NWE-2188-4465

November 4, 2024

Re: NorthWestern Energy filing Revised Five Year (2019-2023) Drawdown Report for Black Eagle, Rainbow, Cochrane, Ryan, and Morony Reservoirs per Project 2188 License Article 403

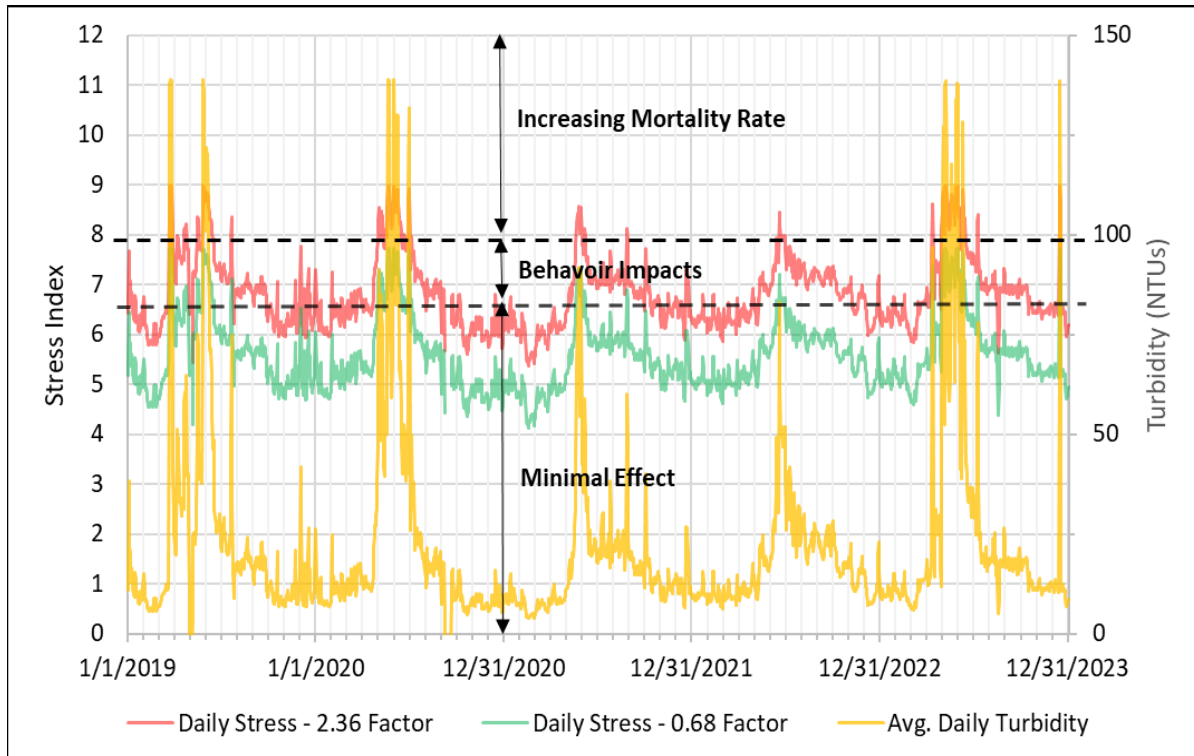
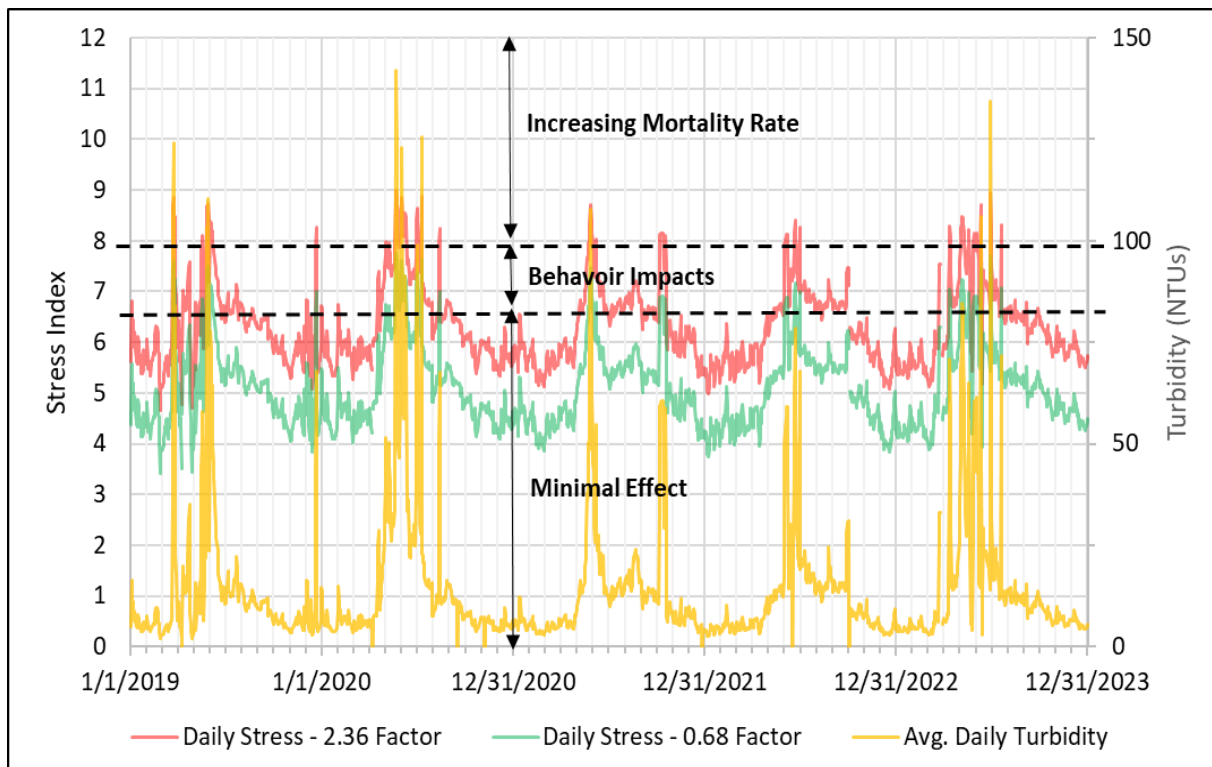
Examination of the Stress Index graphs is difficult as the drawdown periods are not identified. It appears to show spikes above the base level for that time associated with the Black Eagle July 2019 drawdown (peaks with increasing mortality rate for the 2.36 factor) and September 2021 Rainbow drawdown (peaks with behavioral Impacts).

Our recommendation would be to delete the sentence and focus on the change in Stress Index values associated with the drawdown events.

2. We believe section 10 of the document is thorough and does a good job of characterizing the types of stress potentially realized from the drawdowns. We have added a lot to this analysis over the last couple iterations of this report and supplemented it with numerous references to back up our statements. Relative to your comment specifically on the stress indices and your recommendation to clarify the statement, can you please provide us some additional information to back up your perspective and also provide proposed language for the report you believe more accurately represents the stress to fish health?
